Response to Comments for the Draft Stormwater Quality Manual and Draft Guidelines on Soil Erosion and Sediment Control

This document contains the comments provided during the public comment period (January 25th to March 1st, 2023) and the resolution of each comment, to support the Draft Stormwater Quality Manual and Draft Guidelines for Soil Erosion and Sediment Control Guidelines.

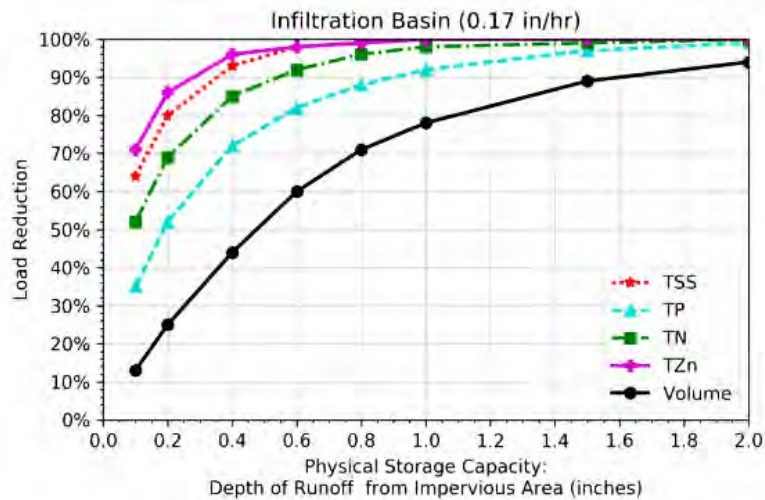
[RE Table 4.1, Standard 2] Analyzing and controlling storm events from every discharge location along a linear project is not feasible. Add Footnote: Linear projects have alternative standards and may take an alternative approach to address constraints that are different than those that affect traditional parcel development projects. These alternative linear project standards can be found in the CTDOT drainage manual, the CTDOT MS4 General Permit and in the supporting materials that CTDOT has developed. (*CT DOT*)

Foot note accepted with minor revisions.

Per the CTDOT MS4 Permit, linear projects have alternative standards and may take an alternative approach to address constraints that are different than those that affect traditional parcel development projects. These alternative linear project standards can be found in the CTDOT drainage manual, the CTDOT MS4 General Permit, **the Construction General Permit** and in the supporting materials that CTDOT has developed.

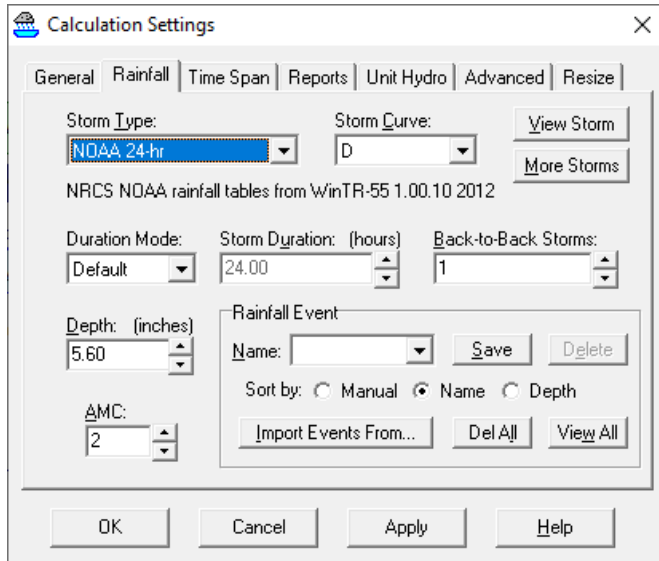
The latest build for HydroCAD (ver. 10.20-2g) contains all 4 NOAA-14 Rainfall Distributions; including type D. It’s housed within the Calculation Settings panel see screenshot below:

I just skimmed the rainfall appendix in one of the manuals, but I would like to understand better why Distribution D was used for CT. (Terrance Gallagher, P.E., Luchs Consulting Engineers, LLC)
